Access Compliance Report

Public Rights-of-Way

(Curb Ramps)

Intersection ID: 26367	Main Street: BEVINGTON_PL	Cross Street: GLYNMOOR_LAKES_DR	Location:	N
ADA ID: 30BA36B95796	Ramp Type: PerpDiag	Initial Pass/Fail: Fail	Overall Compliance: No	Severity Score: 10
Codes/Mitigation Info/Possible Solution		Field Measurements/Component Compliance

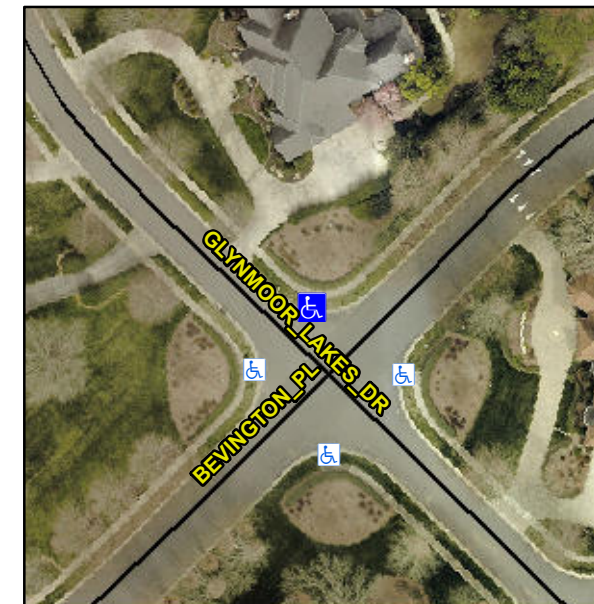
Not Found, R304.5.1, R304.5.3

Compliance	Description	Data	Compliance	Description	Data
N/A	Ramp Length (in)	119.0	Yes	Ramp Slope (%)	6.0
No	Ramp Width (in)	36.0	No	Ramp XSlope (%)	3.2
N/A	Flare Type LT	N/A	N/A	Flare Type RT	N/A
N/A	Flare Slope LT (%)	N/A	N/A	Flare Slope RT (%)	N/A
N/A	Flare Traversable LT?	N/A	N/A	Flare Traversable RT?	N/A
N/A	Landing Length (in)	N/A	N/A	DWS Provided?	N/A
N/A	Landing Width (in)	N/A	N/A	DWS Contrast?	N/A
N/A	Landing Slope (%)	N/A	N/A	DWS Length (in)	N/A
N/A	Landing X Slope (%)	N/A	N/A	DWS Full Width?	N/A
N/A	Landing Curb? (Y/N)	N/A	N/A	DWS Offset (in)	N/A
N/A	Shared Landing?	N/A			
N/A	Gutter Ponding?	N/A	N/A	Gutter Slope (%)	N/A
N/A	Gutter Lip Ht (in)	N/A	N/A	Gutter X Slope (%)	N/A
N/A	Painted X Walk1?	No	N/A	Painted X Walk2?	No
	X Walk 1 Direction	To SW		X Walk 2 Direction	To SE
N/A	X Walk 1 Width (in)	N/A	N/A	X Walk 2 Width (in)	N/A
	X Walk 1 Slope (%)	3.8		X Walk 2 Slope (%)	2.1
	X Walk 1 X Slope (%)	2.1		X Walk 2 X Slope (%)	1.7

Remove & Replace Curb Ramp With Two New Directional Ramps or Equivalent.
